COMMONWEALTH OF KENTUCKY
BEFORE THE ELECTRIC GENERATION
AND TRANSMISSION SITING BOARD

Case No. 2024-00105

PIKE COUNTY SOLAR PROJECT, LLC'S RESPONSES TO
BOARD STAFF'S SECOND SET OF DATA REQUESTS

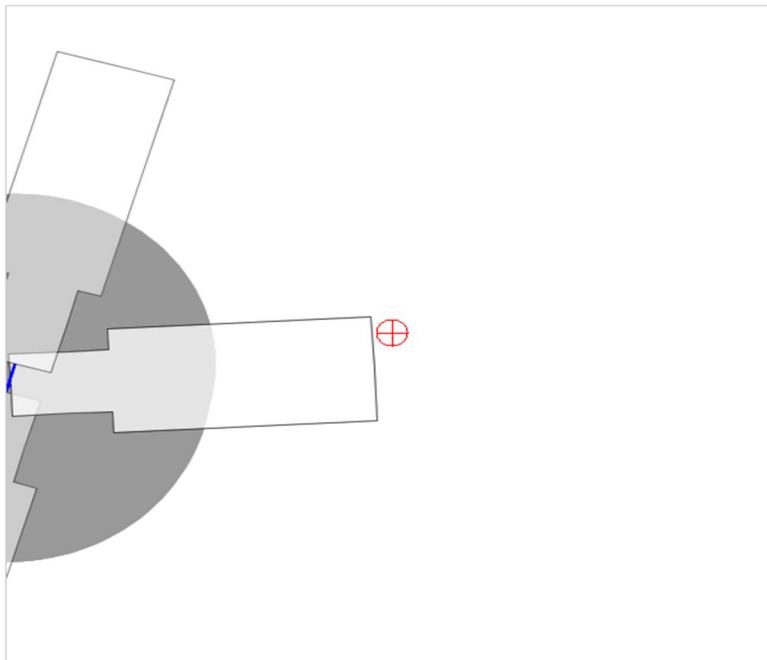
48. Refer to Applicant’s response to Staff’s First Request, Items 48–49. Provide any updated information for each request.

RESPONSE: Applicant has reviewed and believes the Federal Aviation Administration’s Notice Criteria Tool requires filing. Applicant will coordinate with FAA as necessary. No further coordination has taken place to date with the FAA or the Pike County Airport. Applicant expects such coordination to occur prior to the start of construction.

You exceed the following Notice Criteria:

Your proposed structure is in proximity to a navigation facility and may impact the assurance of navigation signal reception. The FAA, in accordance with 77.9, requests that you file.
